Helitowcart - DESIG	GN CHANGE REQUEST-ORDER (ECI	R/ECO)	F20-01	Page 1 of 3
Reviewed & approve		(VLOO)	1 20-01	2006 09 09
	,			2000 00 00
A- REQUEST	EC	CR:	ECC	o: <u> </u>
Nature of proposed change :	MODIFYING PAD OF BP3 DART SKID TUBE WITH W THIS WOULD EXIMINATE THE	350 TO VEARSHO BOLT W	BETTER E BOCTE EARING	FIT THE SON. OF PADS
Reason :	BOCTS WEAR THE PAD	) <i>&amp;</i>		
Submitted By:	SiMON EBACHER CAN HELY JAN 14, 2016	)= \$/V	Anheie	BARRESU
Date :	JAN 14, 2016	,		, ,,,,,,,,,,,,,,,,,,,,,,,,,,,,,,,,,,,,,
	,			
B- IMPACT ANALY Product	SIS			
Manager				
iviariagei				
	Signature : D. Marleau	/date :_	2016042	26
Operation Manager	Signature: of Dascace		ol6 of 2	
Quality	Signature . A Succession	/date 🔏	3/6 44 2	20
System Manager	Signature: Dauleau	/date : <i></i> /	Tore 04 2	<u> </u>
Regulatory affairs Manager	Signature: Di Januare	/date :	96 04 d	26
Supplier A  AVATECH	· KENAUD - BEATHEROT. RIC LEONSLICTED PRIOR TO TRIGGE	HER

Helitowcart - DESIGN CHANGE REQUEST-ORDER	(ECR/ECO)	F20-01	Page 2 of 3
Reviewed & approved by:	1		2006 09 09

## Eurocopter Model AS 350/355 Series Helicopters Installation of BearPaw Model BP350

Report: HTC-MDL-BP-AS350/355-1000 (Rev H)

# Streamline Pad with Recesses - Dwg 314-0018-01 (VNR106-S) Rev E

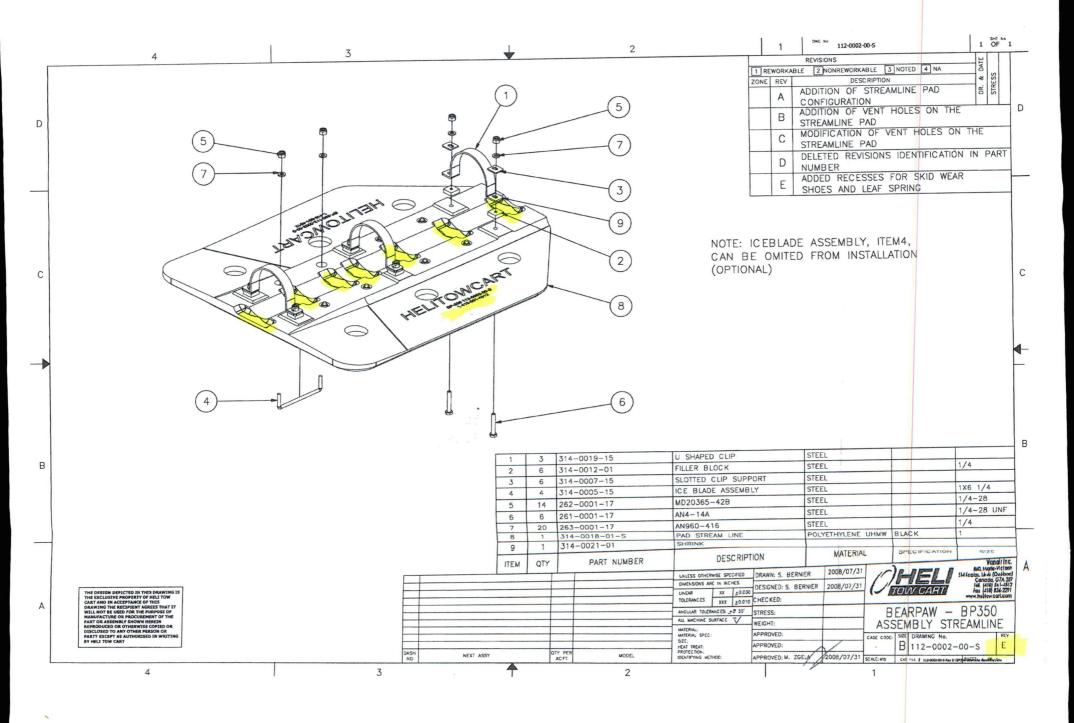
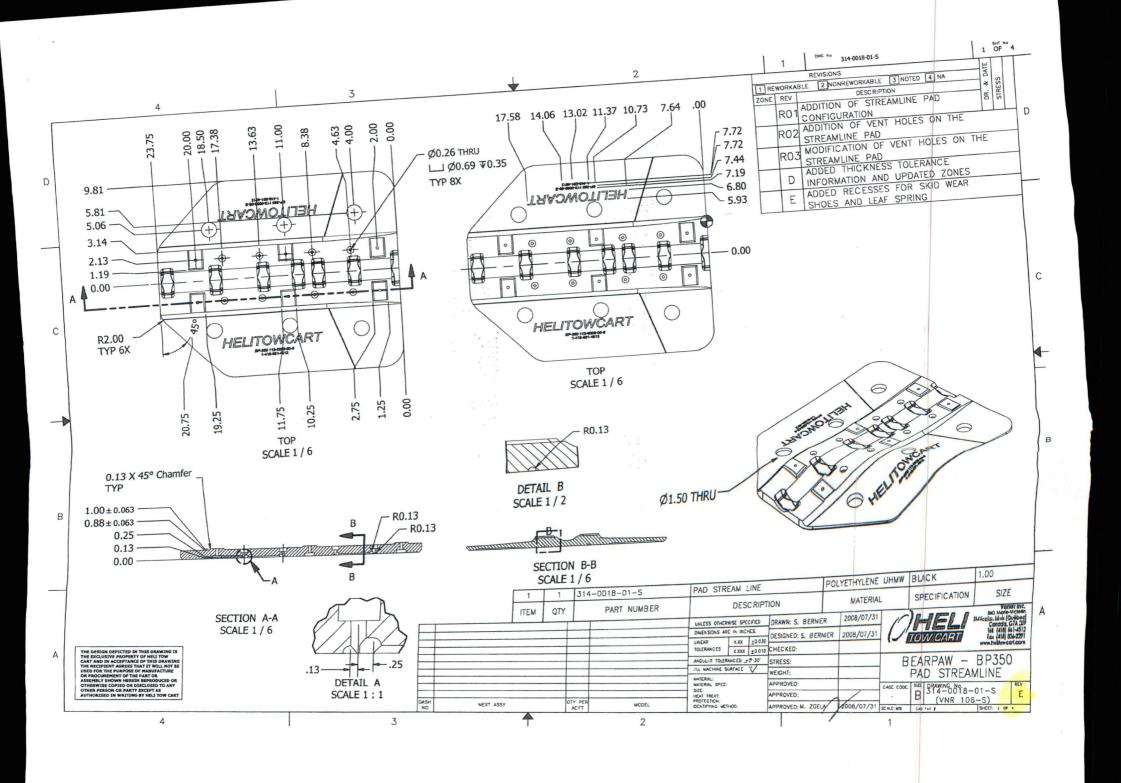
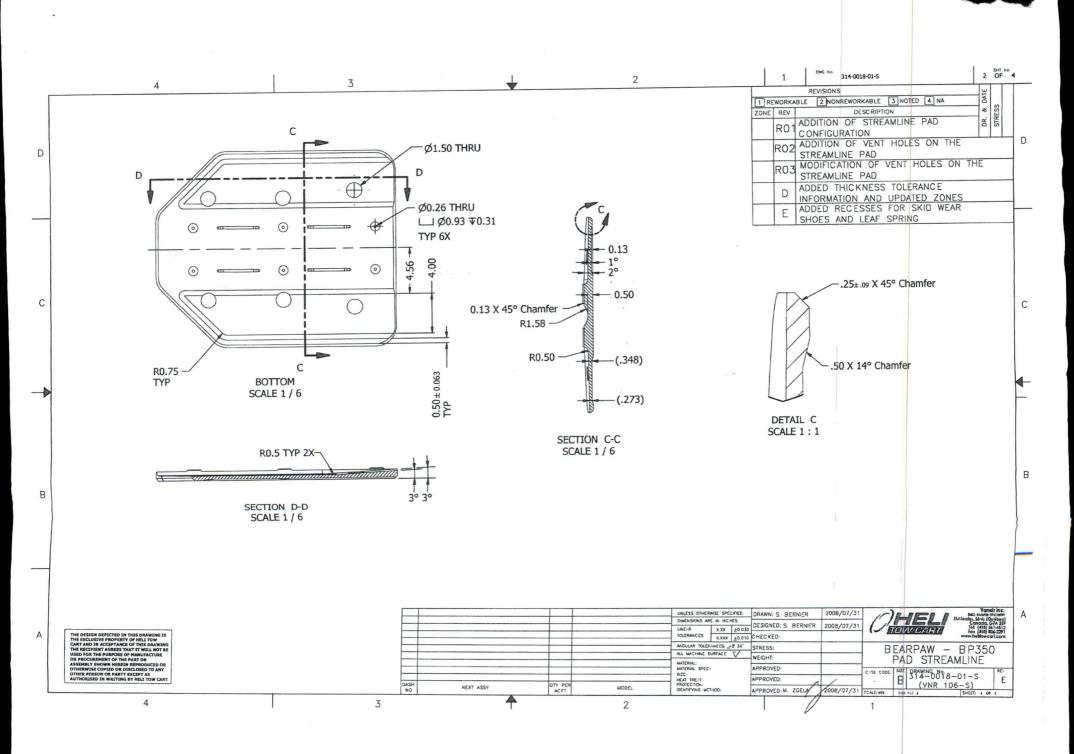
BearPaw Pad, dwg no. 314-0018-01-S (VNR106-S) Rev E for Streamline pad with recesses.

Action	Resp	Due date :	Verified by :
•	Aviarect TO EDMM WITH CAN HELI	DB	2016 0630	DR
	FOR BEST EDT OF NEEDS X SIMON EBACKER & RENAUD BERTHELDT-	2:CHER	HAVE CON	н.~
	LIST OF DOCS CHANGED.			
•	PAD DOUG 314-0018-01-5 rev D-2 rev.	E «	3016 06 30	AS .
-	Assy DWG- 112.0002-00-5 res D-> rev	E		NB
-	TUSTALL. INST HTC-314-0020-00E NO	r.F-	rev. G	AB.
•	MDL BP- AS350+355 - 1000 rev. G-	rev.H	V	Reviewed
			2	616 09 22
9	LPDATE ALL IN MY COMPUTER +SE	ever:		201609 22

# BearPaw Model BP350

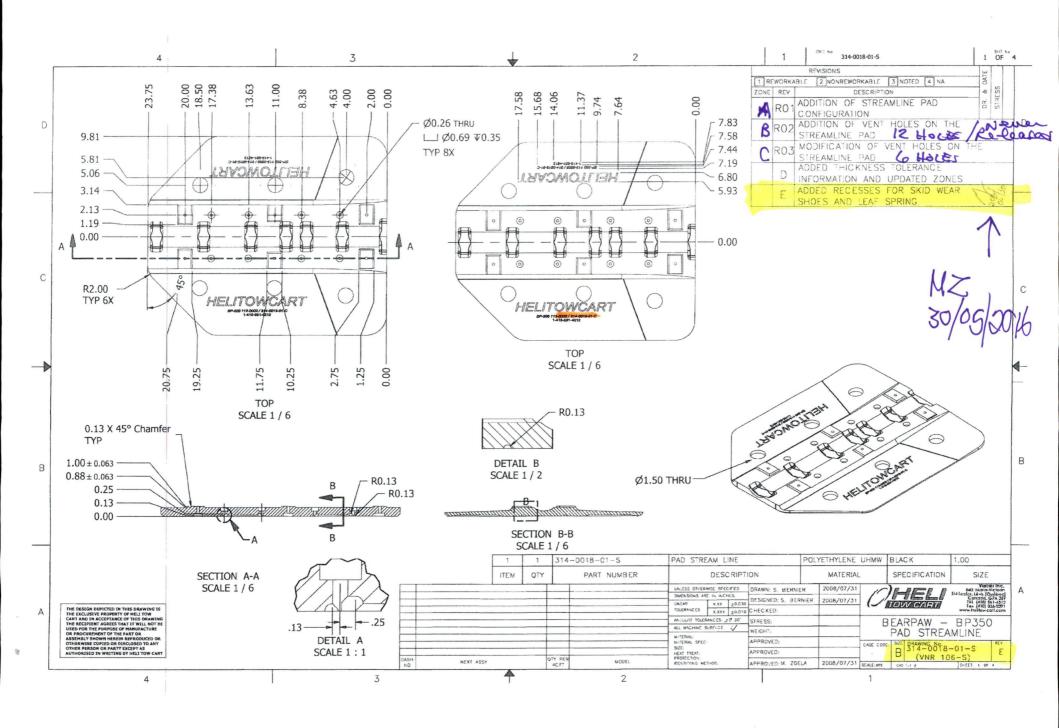
The old configuration was as per drawing #VNR106-S, BearPaw BP350 Pad Streamline, Rev A, dated Feb 29, 2008

The new configuration of Bear Paw is as per drawing #VNR106-S, BearPaw BP350 Pad Streamline, Rev R03, dated July 31, 2008.

Structural substantiation: The introduction of the vent holes has a negligible effect on the strength of the BearPaw and is documented in the following memorandum # HTC-MEM-0709-001, Memorandum - Vent Holes BP350 BearPaw, Rev A, dated July 31, 2008

Drill the hole pattern as per drawing #VNR106-S, BearPaw BP350 Pad Streamline, Rev R03, dated July 31, 2008

## Concept 1 Chanfrein sur toute la longueur

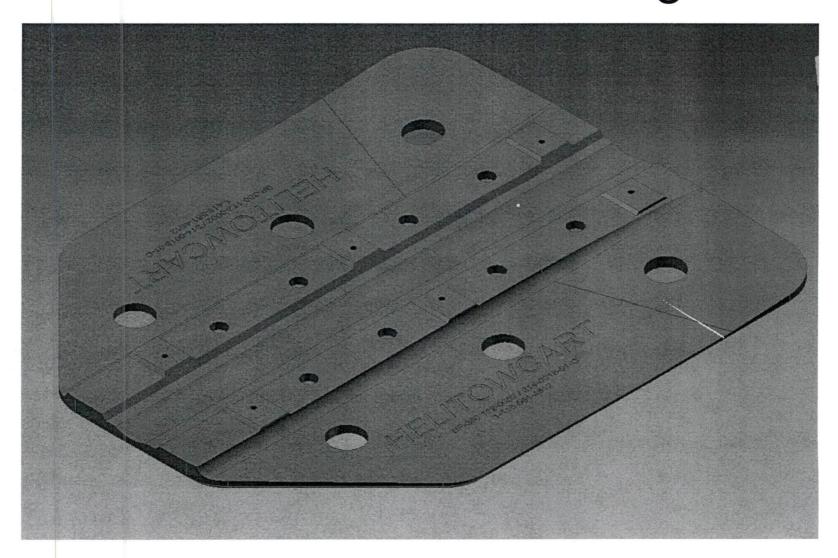
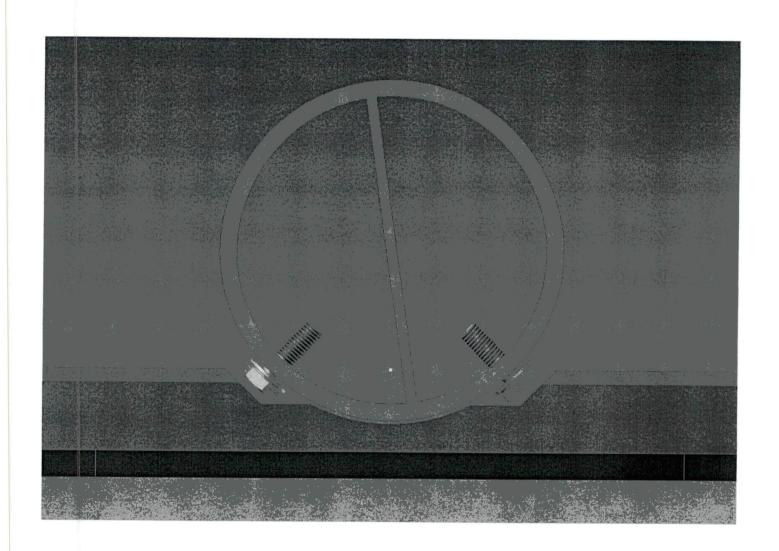
## Modification des BP-350 pour les wear pads de Dart

### Concept 2 Chanfreins locaux

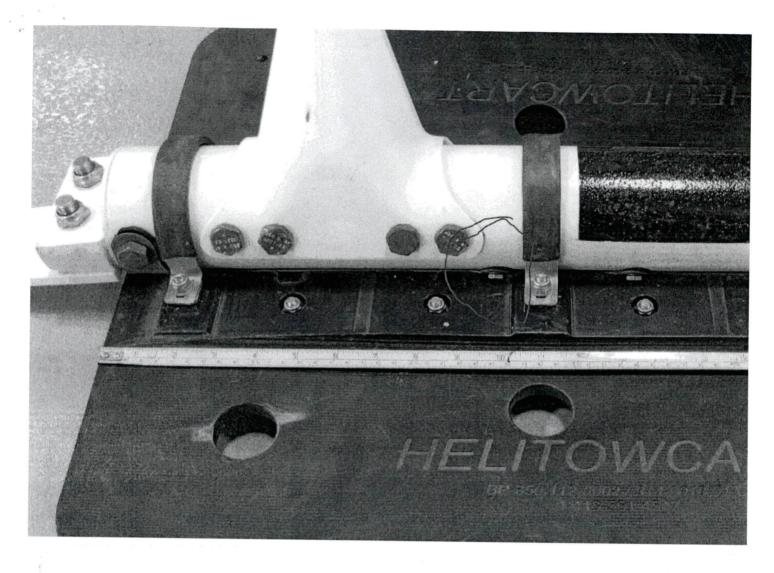
### Petites modifications qui pourraient être apportées au design:

- Ajouter un "recess" à l'arrière du bearpaws pour éviter l'usure avec la spring blade du skid tube (on en a déjà discuté).
- Avoir la possibilité, comme ceux de Dart, de déplacer la clamp du milieu afin de prévenir le mouvement avant / arrière du bearpaws. Par contre, il faudrit modifier les blocs du centre afin de ne pas avoir trop d'interférence avec la bolt du wearshoe qui est directement situé à cette endroit (voir photo plus bas)
